From: Kristen Kapelanski, AICP  
Date: 6/4/2019  
Re: **Level One Bank (City File #19-015)**  
**Site Plan - Planning Review #1**

From: Mark Artinian, R.A., Building Inspector/Plan Reviewer  
To: Kristen Kapelanski, Planning Department  
Date: May 28, 2019  
Re: Level One Bank  
1880 S Rochester Rd  
Sidwell: 15-22-451-030  
City File: 19-015

To: Kristen Kapelanski  
From: Matt Einheuser  
Date: April 25, 2019  
Re: Level One Bank – Review #1  
File #19-015

Reference: **Level One Bank – Rochester Hills, CAMS #201900274**  
**Part of the SE ¼ of Section 22, City of Rochester Hills**

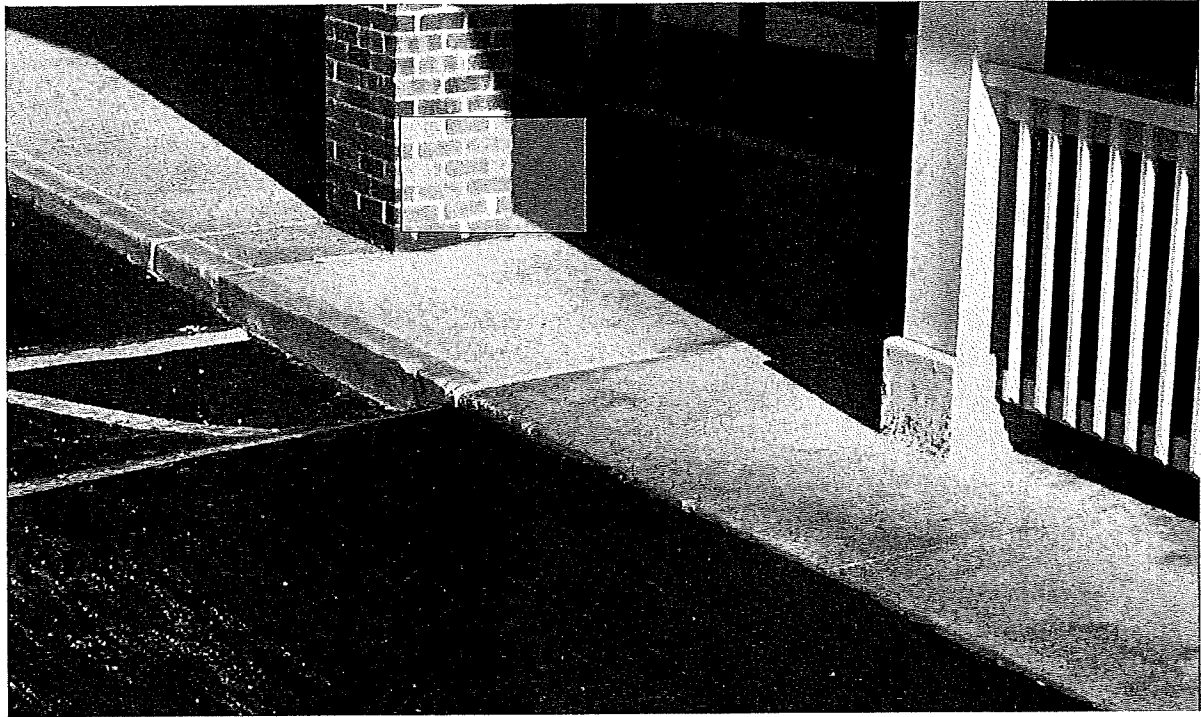
The proposed accessible path is unsafe due to the narrow passageway from the parking lot to the sidewalk and the close proximity to the sloped asphalt at the existing route. Refer to the attached photo. Use the existing accessible route and provide the curb cut as noted above.
